PRODUCT/PROCESS CHANGE NOTICE (PCN)

PCN #: TB-0609-02 DATE: 06-Oct-2006 Product Affected: SOJ 28L, 32L, 36L Products shipped in tube Date Effective: 06-Jan-2007	MEANS OF DISTINGUISHING CHANGED DEVICES: <input type="checkbox"/> Product Mark <input type="checkbox"/> Back Mark <input type="checkbox"/> Date Code <input checked="" type="checkbox"/> Other Rev. 08 printed on shipping tube
---	---

ATTACHMENT I - PCN #: TB-0609-02

TOLERANCES UNLESS OTHERWISE SPECIFIED		DECIMALS		ANGLE	
.XX ±.25		.XXX ±.13		.XXX ±.13	
APPROVALS		DATE		SCALE	
DRAWN		DATE		N/A	
CHECKED		DATE		SIZE	
TITLE: PB/PBG 28/32/36 SHIPPING TUBE		STOCK NO. P1-069-000		DRAWING NO. MSC-3026	
DO NOT SCALE DRAWING		SHEET 1 OF 1		REV 14

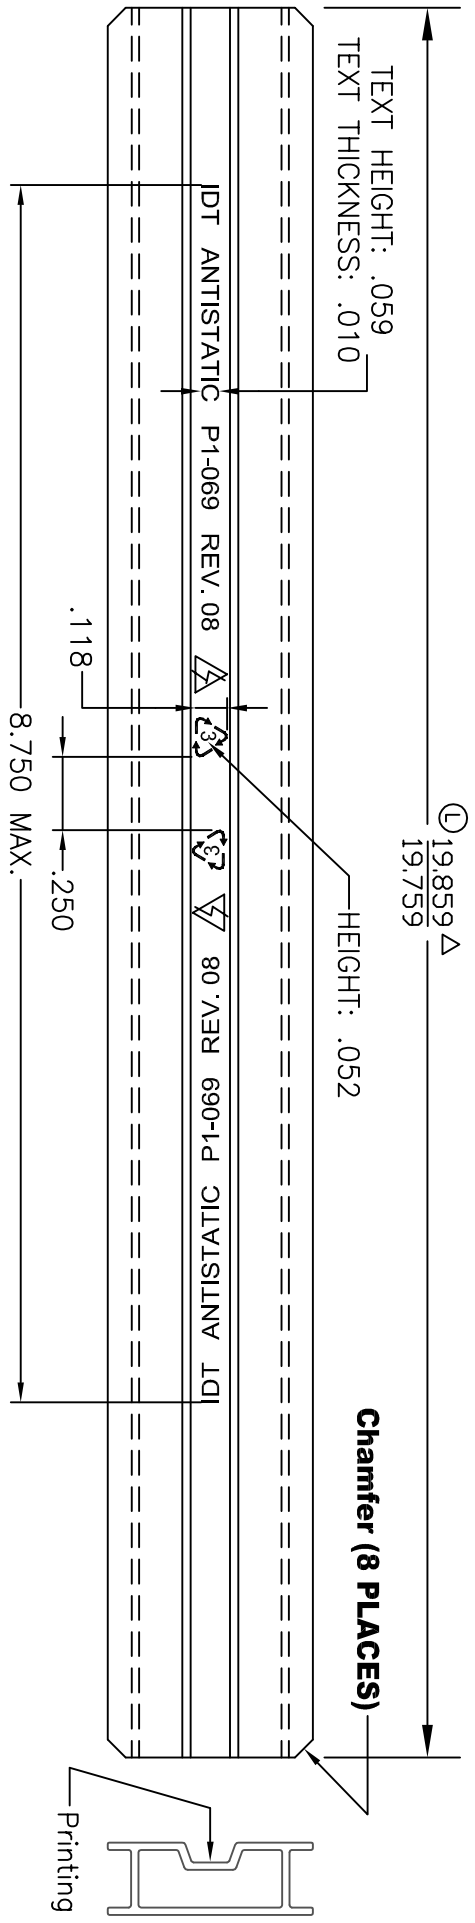
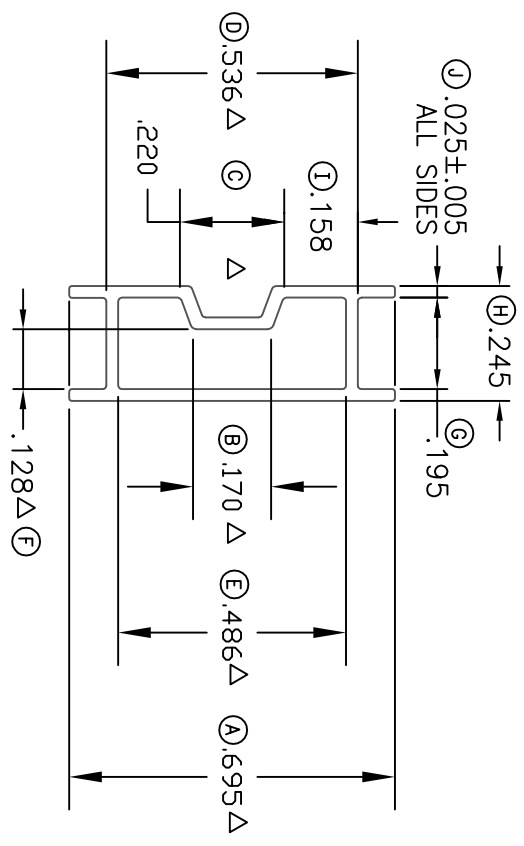
Detail of Change: This notification is to advise our customer that IDT has qualified new shipping tubes for SOJ 28L, 32L, 36L products. The new shipping tubes have an increase in the tube opening height from 0.105 inches to 0.128 inches to provide better protection for packages during assembly, test and backend processes.

** Note: Tube opening height is denoted as dimension 'F' in the tube drawing. See attachment for the drawing.*

REVISIONS				
REV	DESCRIPTION	DATE	APPROVED	
13	INCLUDED ITW MERITEX AS SUPPLIER	03/11/06	KK Three	
14	INCREASE (F) FROM 0.105" TO 0.128"	08/24/06	KK Three
